Proposal for Supplement 5 to the 04 Regulation No. 44 (CHILD RESTRAINT SYSTEM)

Note: The text reproduced below was prepared by the expert from CLEPA in order to maintain the link between the label in the child restraint system and the label present in vehicles.

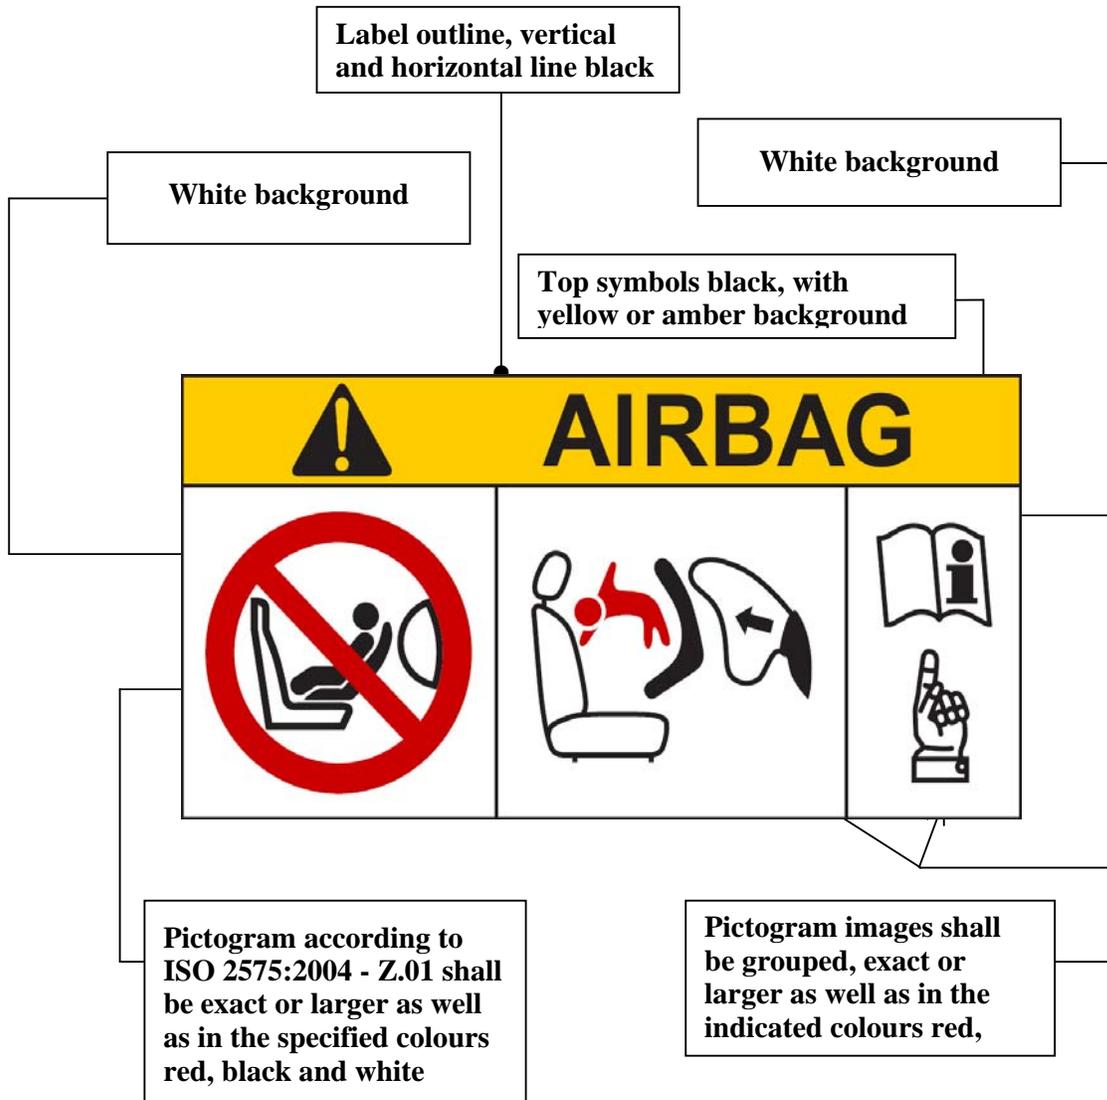
Paragraph 4.4., shall be deleted

Insert a new paragraph 4.4., to read:

"4.4. On the visible inner surface (including the side wing beside the child's head) in the approximate area where the child's head rests within the Child Restraint System, rearward facing restraints shall have the following label permanently attached (the information shown is a minimum).

Label minimum size: 60 x 120 mm.

The label shall be stitched to the cover around its entire perimeter and/or permanently bonded to the cover over its entire back surface. Any other form of attachment that is permanent and not liable to removal from the product or to becoming obscured is acceptable. Flag type labels are specifically prohibited.

If sections of the restraint or any accessories supplied by the Child Restraint System manufacturer are able to obscure the label an additional label is required. One warning label shall be permanently visible in all situations when the restraint is prepared for use in any configuration.

The current label describes the dangers of using a child restraint system with an active front seat passenger airbag. It was matching to the vehicle label style for easy recognition by consumers.

The vehicle label is described in R94, and it was recently changed into a label style without text.

The proposed label is intended to re-establish the link between the new R94 vehicle label and the label on child restraint systems.
